**Remediation System Evaluation (RSE)**  
**Moss-American Superfund Site**  
**Milwaukee, Wisconsin**

# REMEDIATION SYSTEM EVALUATION MOSS-AMERICAN SUPERFUND SITE MILWAUKEE, WISCONSIN

Final Report  
March 2011

Prepared for:  
US Environmental Protection Agency  
Region 5

Figure A-4. Excavation at MW-34S.

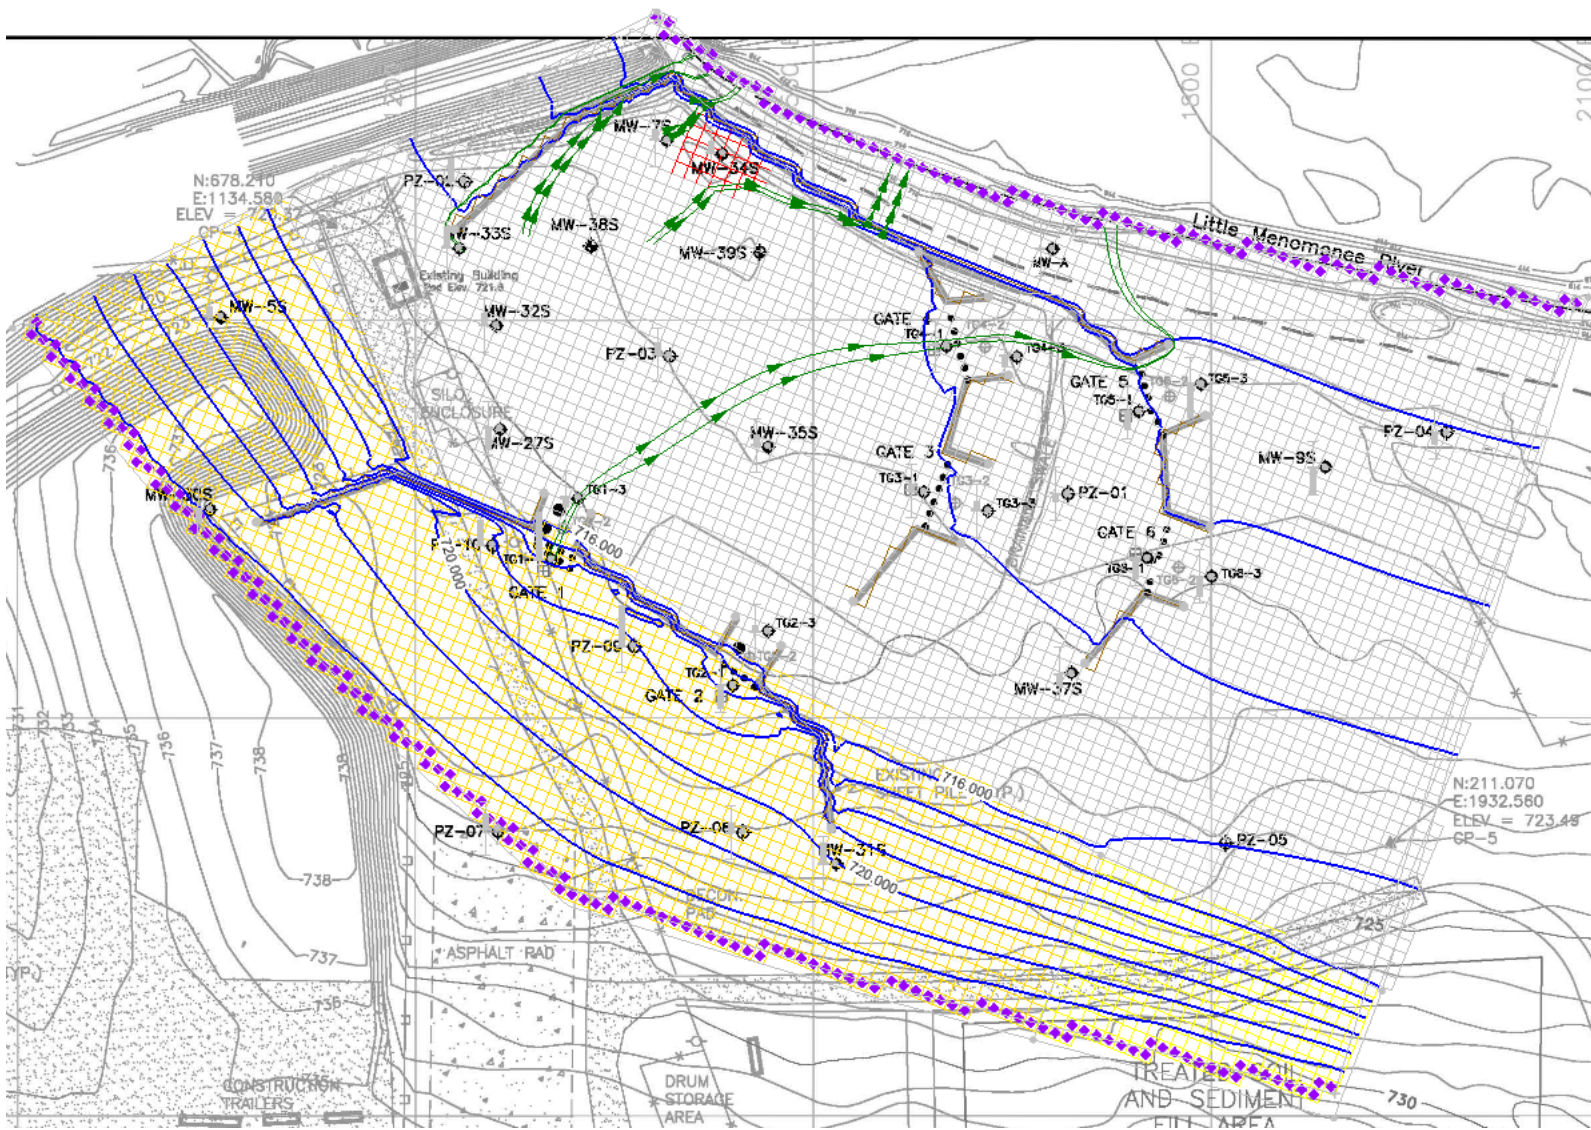
Oxygen Releasing Compound Advanced (ORC Advanced<sup>®</sup>) could be incorporated into the excavation backfill to enhance biodegradation of dissolved-phase contaminants in both the excavation and groundwater. Because molecular oxygen would subsequently diffuse into groundwater surrounding the ORC Advanced<sup>®</sup> amended backfilled area, biodegradation of dissolved-phase contaminants would be enhanced in surrounding groundwater as well. The groundwater model also showed that there would be some localized groundwater flow into the ORC backfilled area (Figure A-4).

Figure A-4 shows the groundwater elevation contours for the Excavation at MW-34S scenario. This scenario includes excavation of NAPL containing soils around MW-34S (shown in red on Figure A-4) and backfill with sand and ORC. The model shows that there will still be a stagnation area near MW-7S and MW-34S, however, the presence of the higher permeability backfill material may induce localized flow toward the treated excavation area. This scenario does not impact the potential groundwater moving around the end of the sheet pile near MW-33S.

Figure A-5. Small Scale Re-Circulation Cell, Excavation at MW-34S

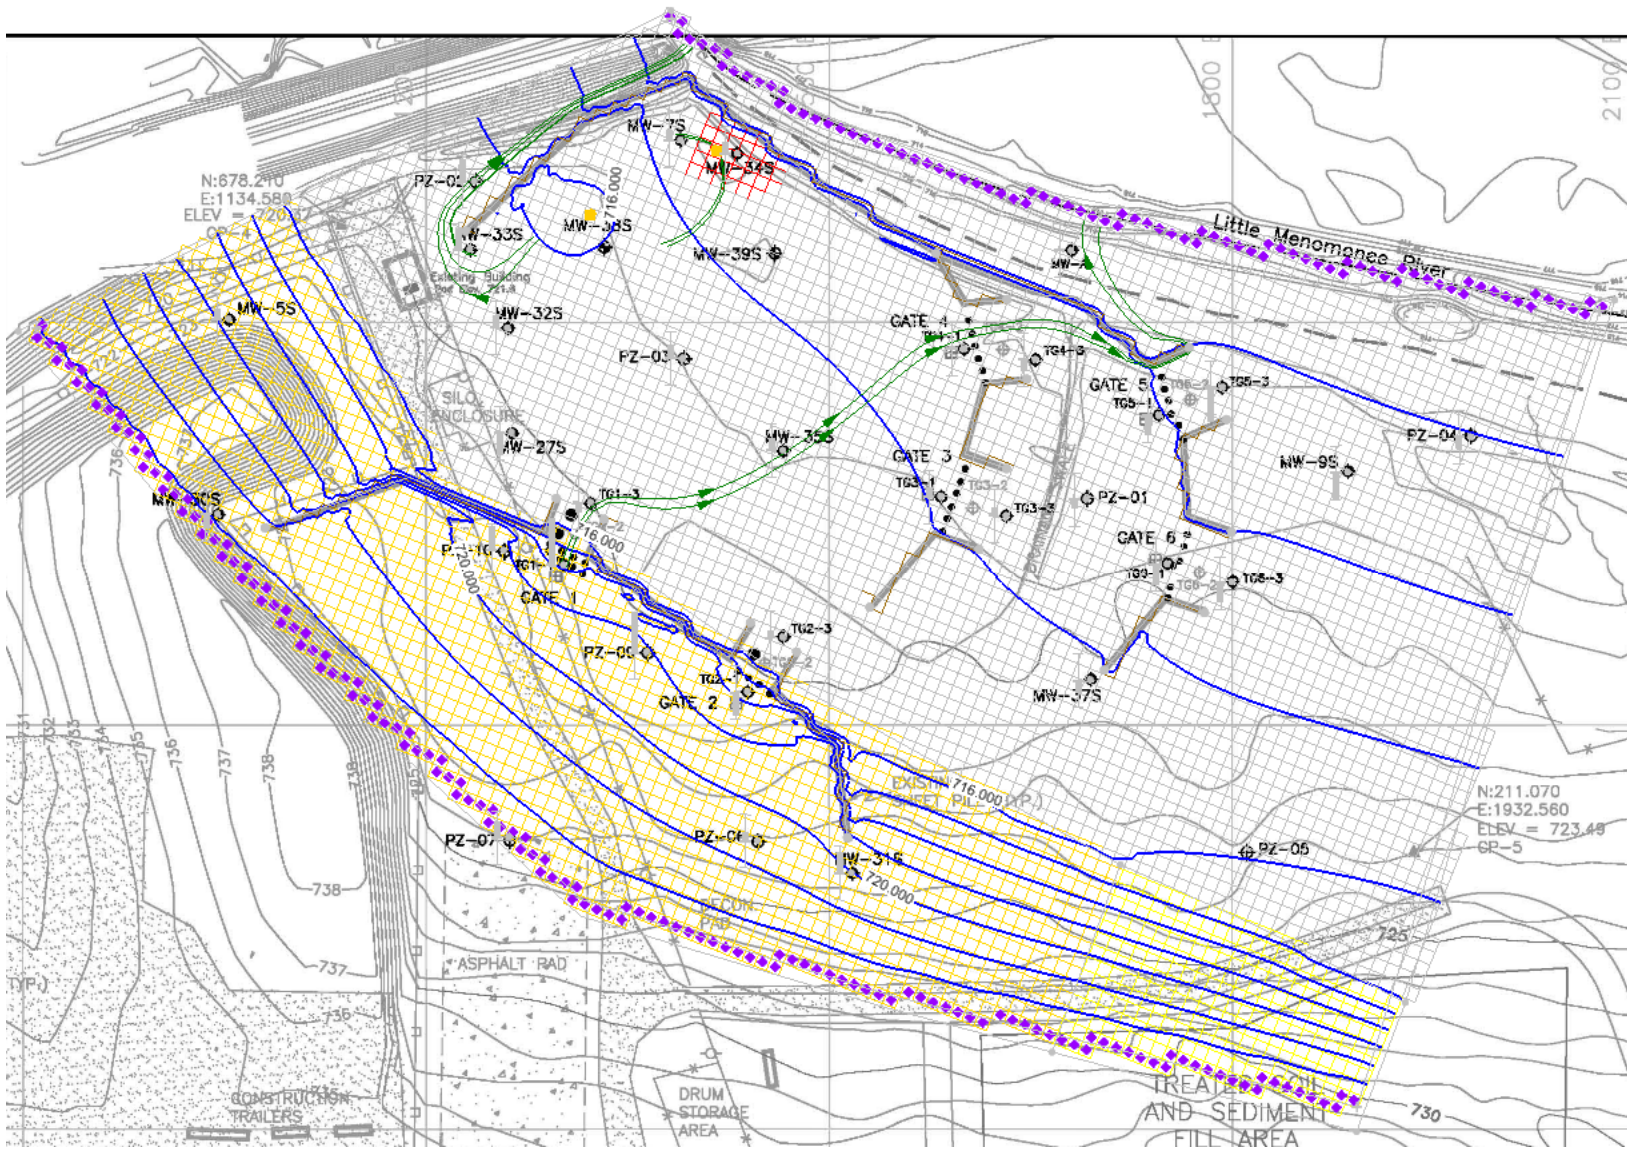
Figure A-5 shows the groundwater elevation contours for the small scale re-circulation cell and excavation at MW-34S. This scenario includes excavation of NAPL containing soils around MW-34S (shown in red on Figure A-5) and backfill with sand and ORC. In addition, a small re-circulation cell would be installed in the north east portion of the system to help distribute ORC to the dissolved phase plume. An extraction well would be installed near MW-34S and an injection well would be installed near MW-38S. Due to the low permeability soils near this area, pumping/injection would be very low (0.5 gpm). The model shows that this type of circulation cell could adequately distribute ORC throughout the remaining dissolved phase plume, however, there will likely be some groundwater mounding near MW-33S that could increase the amount of flow around the end of the sheetpile wall. Additional costs may include treatment of contaminated groundwater prior to re-injection.

Figure A-6. Groundwater Extraction near Gate 5 and 6, Excavation at MW-34S

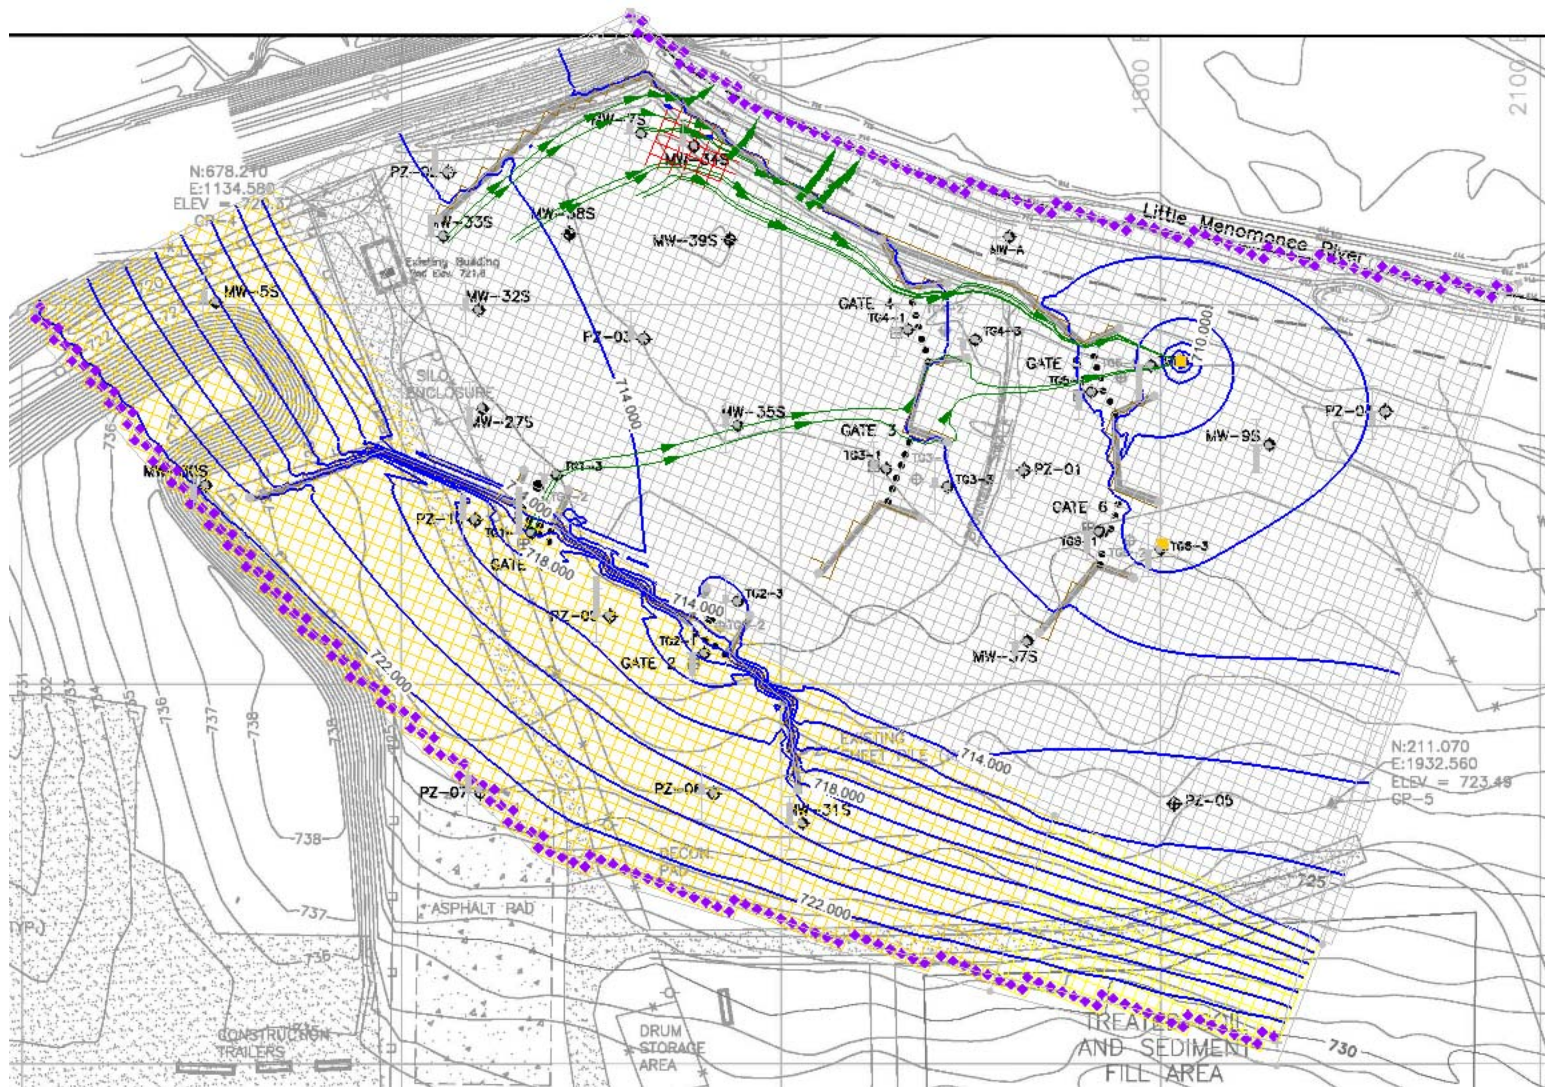
Two model scenarios were evaluated: 1) installation of extraction wells down-gradient of Gates 5 and 6 and 2) installation of a large scale re-circulation cell that includes an injection well near MW-7S and an extraction well down-gradient of Gate 5. The groundwater model shows that even with extraction wells, the groundwater stagnation area may still exist (Figure A-6). The extraction wells induce a slight gradient

Figure A-6 shows the groundwater elevation contours for groundwater extraction near Gates 5 and 6 and excavation at MW-34S. This scenario includes excavation of NAPL containing soils around MW-34S (shown in red on Figure A-6) and backfill with sand and ORC. Two groundwater extraction wells would be installed east of Gates 5 and 6. Due to the low permeability materials, groundwater extraction rates would only be about 0.75 gpm near Gate 5 and 0.25 near Gate 6. The model shows that the groundwater stagnation area near MW-7S and MW-34S still exists, however, flow no longer goes around the end of the sheet pile near MW-33S and groundwater near MW-38S will eventually reach the eastern treatment gates. Since the gradient is very low, it may still take over 30 years for the contaminated groundwater to reach the eastern treatment gates.

Figure A-7. Large Scale Re-Circulation Cell, Excavation at MW-34S

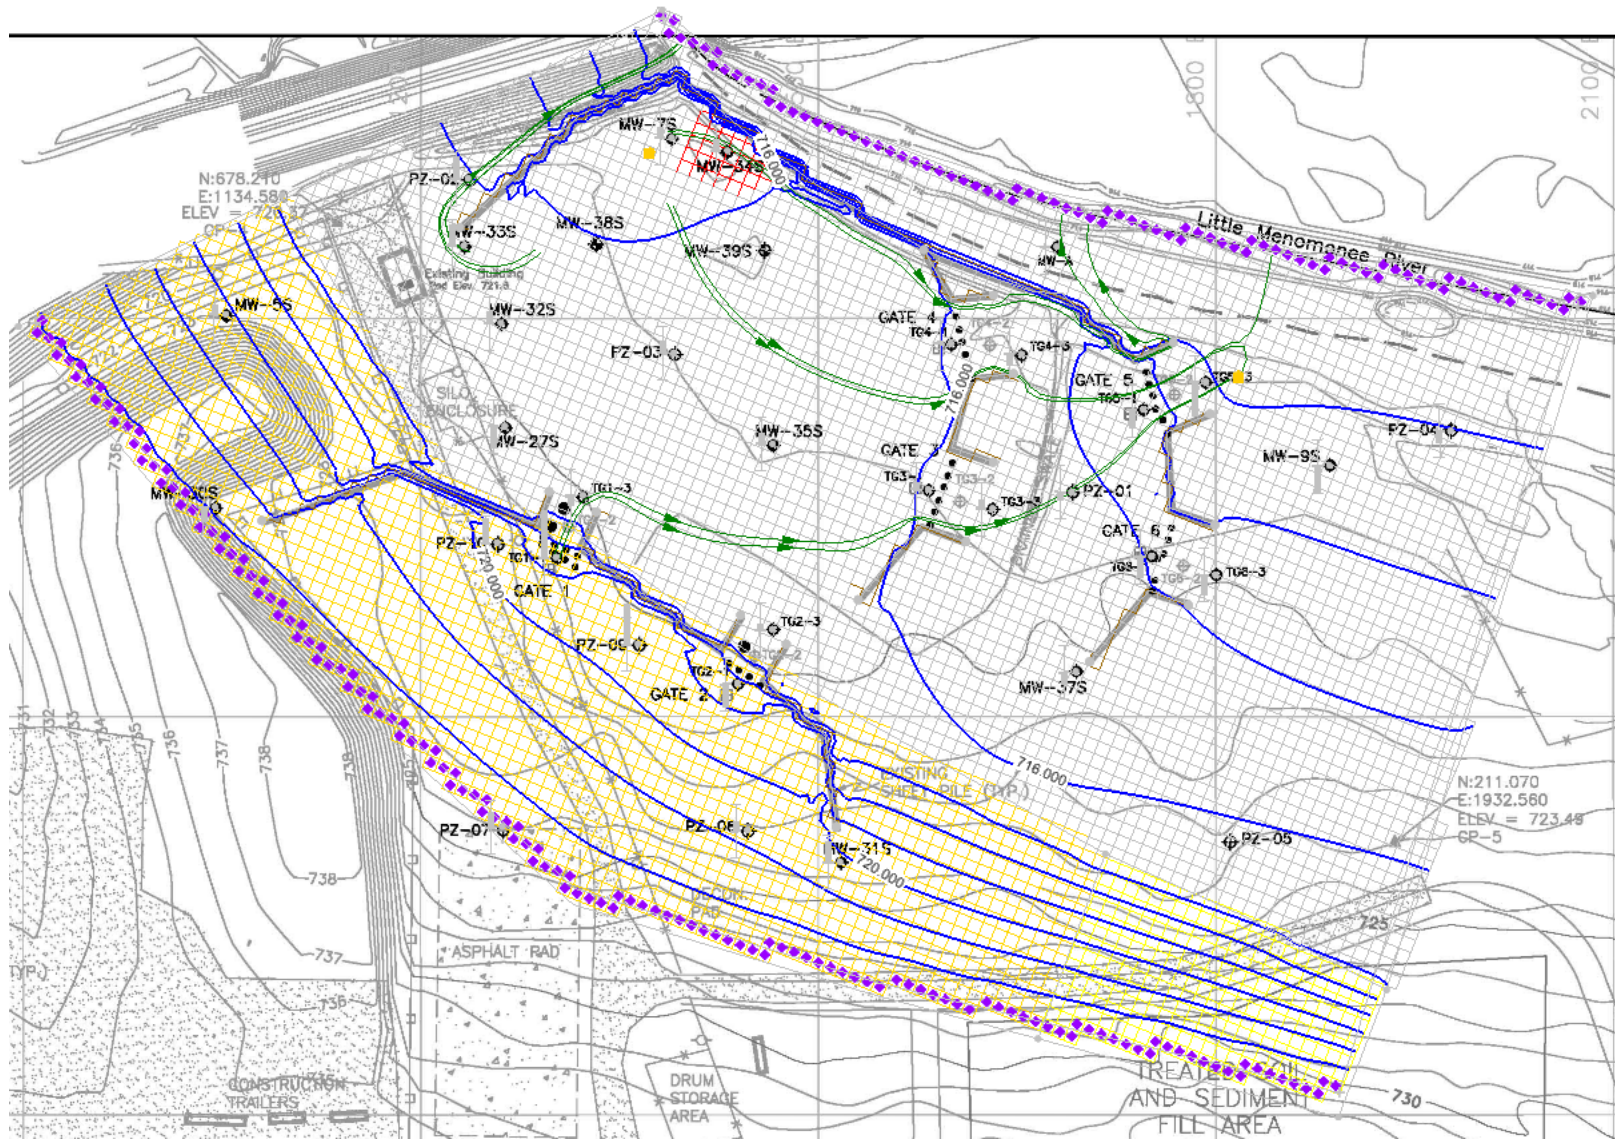
The groundwater model shows that with a large scale re-circulation cell groundwater within the stagnation zone would flow toward the eastern treatment gates; however, there could be increased flow around the end of the sheet pile near MW-33S due to mounding effects (Figure A-7). Again, the low permeability materials would limit the extraction/injection rates. When compared to the extraction well scenario, the gradient across the site is increased, but it could still take over 20 years for contaminated groundwater near the stagnation zone to reach the eastern treatment gates. In addition, such flow modification would encourage contaminated groundwater flow into areas that currently contain low-level contamination, thereby potentially increasing the volume of groundwater contaminated above cleanup levels at the site.

Figure A-7 shows the groundwater elevation contours for the large scale re-circulation cell and excavation at MW-34S. This scenario includes excavation of NAPL containing soils around MW-34S (shown in red on Figure A-7) and backfill with sand and ORC. One extraction well would be installed near Gate 5 and one injection well would be installed near MW-7S to induce flow across the system. Due to the low permeability materials, groundwater extraction/injection rates would be very low (0.25 gpm). The model shows that groundwater near MW-7S and MW-34S would flow toward the eastern treatment gates. Groundwater mounding near MW-33S could increase the amount of flow around the end of the sheet pile wall.

Figure A-8. New Gate North of MW-34S, Excavation at MW-34S

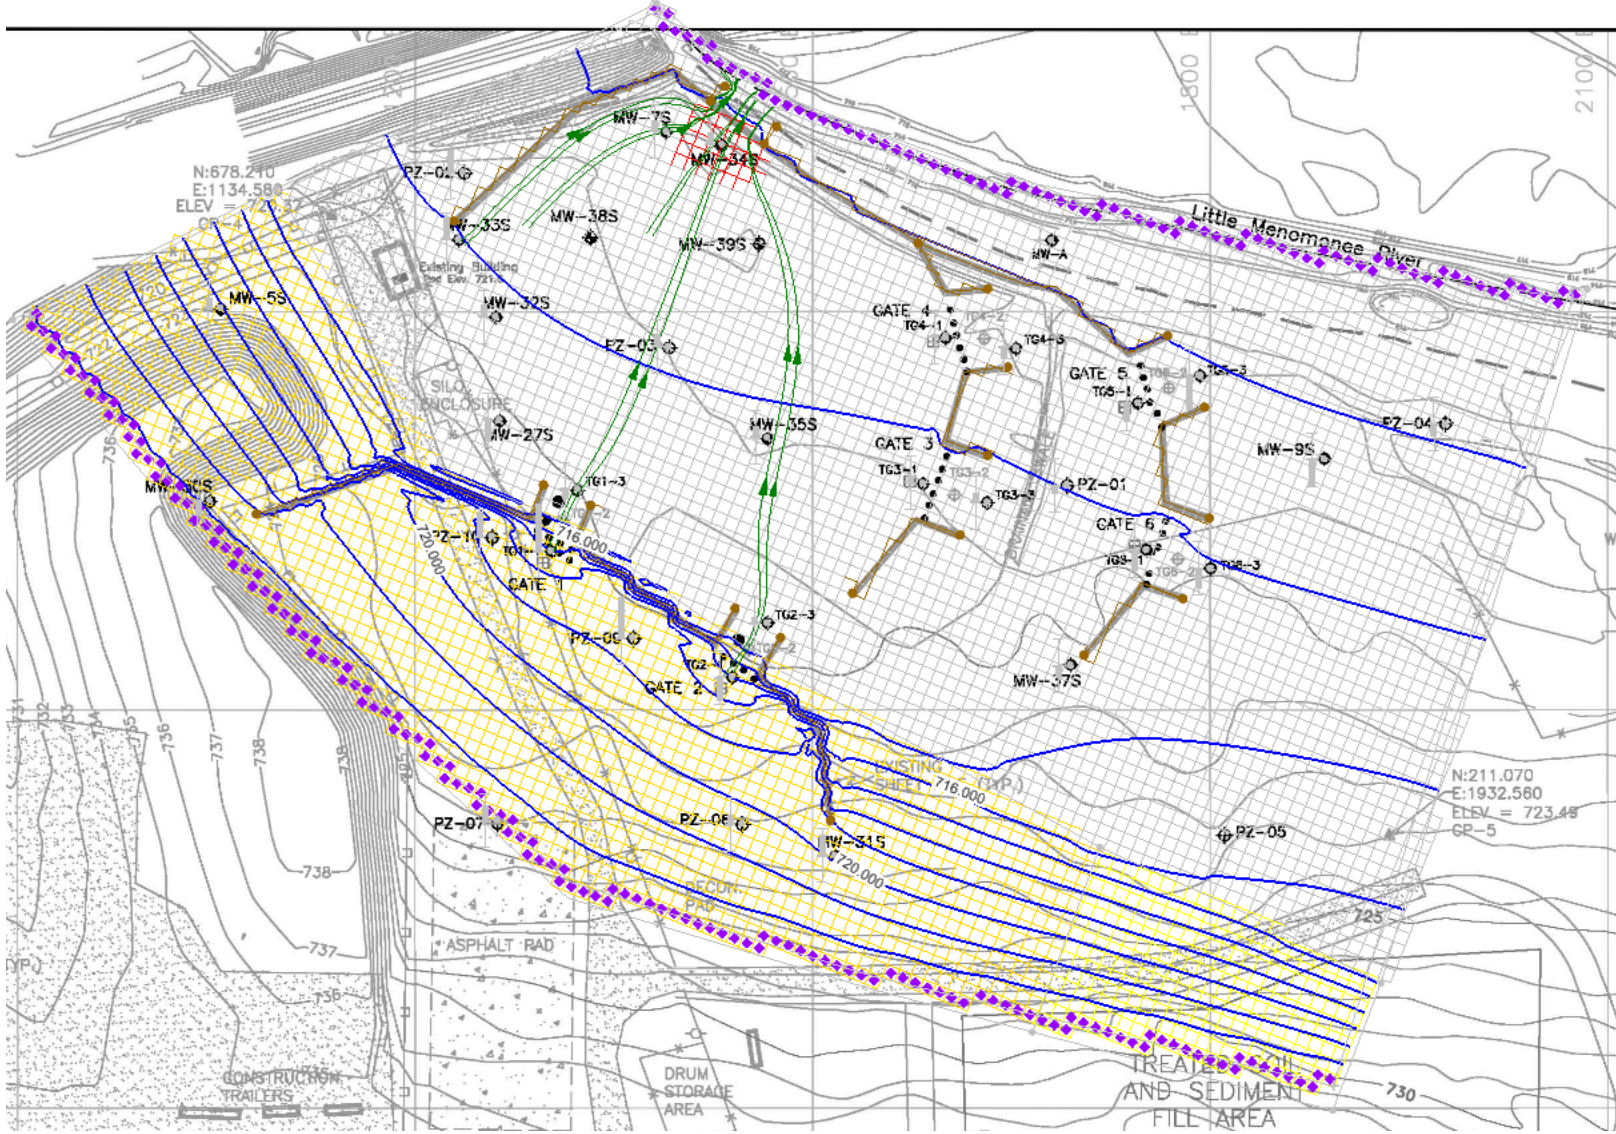
Figure A-8 shows the groundwater elevation contours for a new gate north of MW-34S and excavation at MW-34S. This scenario includes excavation of NAPL containing soils around MW-34S (shown in red on Figure A-8) and backfill with sand and ORC. A new gate with air injection treatment would be installed to the north of MW-34S. The model shows that flow is induced toward the gate from the up-gradient treatment gates, near the area of stagnation at MW-7S, and near MW-33S where groundwater is potentially migrating around the end of the sheet pile.
